**Subject: Dresden Station Unit 2
Proposed Amendment to License and
Appendix A, Technical Specifications,
for Facility Operating License DPR-19
to Support Reload No. 4
NRC Docket No. 50-237**

APPLICABLE TO:
PUBLICATION NO. NEDO-24160
T. I. E. NO. 78NED294
TITLE SUPPLEMENTAL RELOAD
LICENSING SUBMITTAL FOR DRESDEN
NPS UNIT 2 RELOAD 4
ISSUE DATE November 1978

**ERRATA And ADDENDA
SHEET**

Figure 1. Dresden Unit 2 Reload 4 Design Reference Core Loading

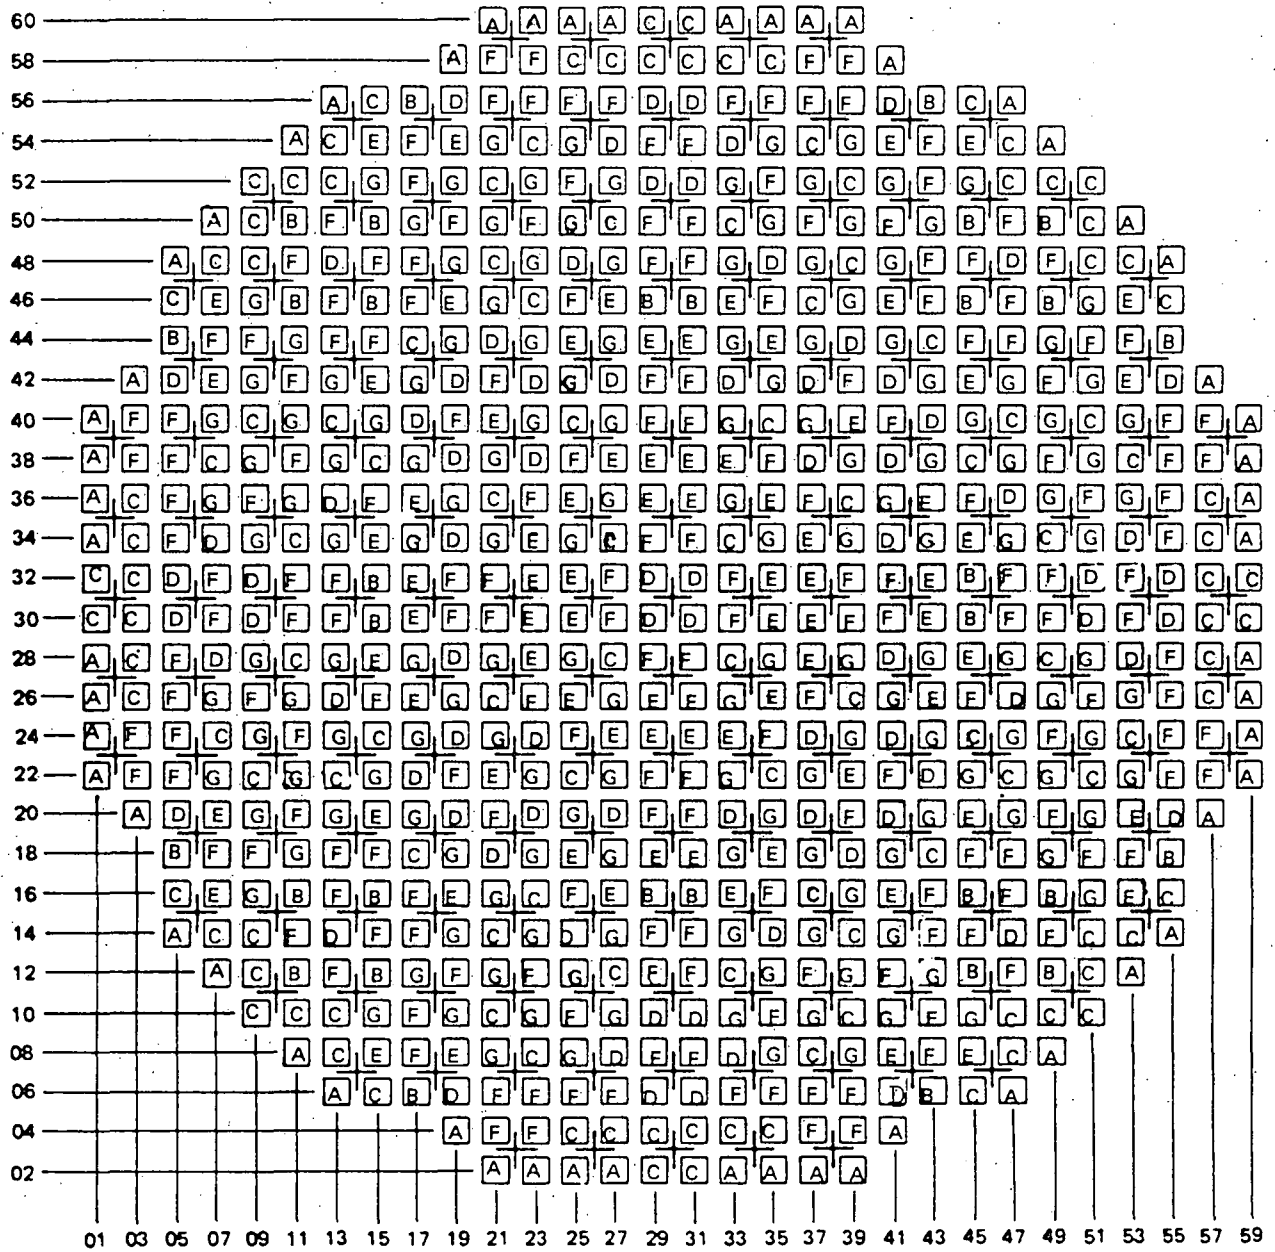
As a result of delaying the originally scheduled shutdown date, an evaluation of the applicability of the reload analysis for Dresden Unit 2, NEDO-24160, was made. This evaluation resulted in a new reference core loading pattern (Figure 1) changes to the core average exposures (Sec. 3) and the core effective multiplication and control system worths (Sec. 4) as presented in NEDO-24160. The shutdown margin remains greater than technical specification requirements. The standby liquid control system shutdown capability was determined to be unchanged from the documented value. The reload transient analysis inputs (Sec. 6) given in the document are the same or conservative for the new core. Thus, the transient analysis (Sec. 9), the over pressure protection analysis (Sec. 12) and the stability analysis (Sec. 13) remain unchanged and are bounding. The GETAB analysis initial conditions (Sec. 7) remain the same. The rod withdrawal error (Sec. 10) was reanalyzed and the values given in the document for the 107% RBM setpoint are conservative. Thus, the operating limit MCFR (Sec. 11) remains unchanged. The changes do not impact on the LOCA analysis (Sec. 14). The control rod drop accident (Sec. 16) has been determined to remain not limiting and, therefore, was not changed.

ITEM	REFERENCES (SECTION, PAGE PARAGRAPH, LINE)	INSTRUCTIONS (CORRECTIONS AND ADDITIONS)
1	Page 1	Replace with new page 1.
2	Page 6	Replace with new page 6.
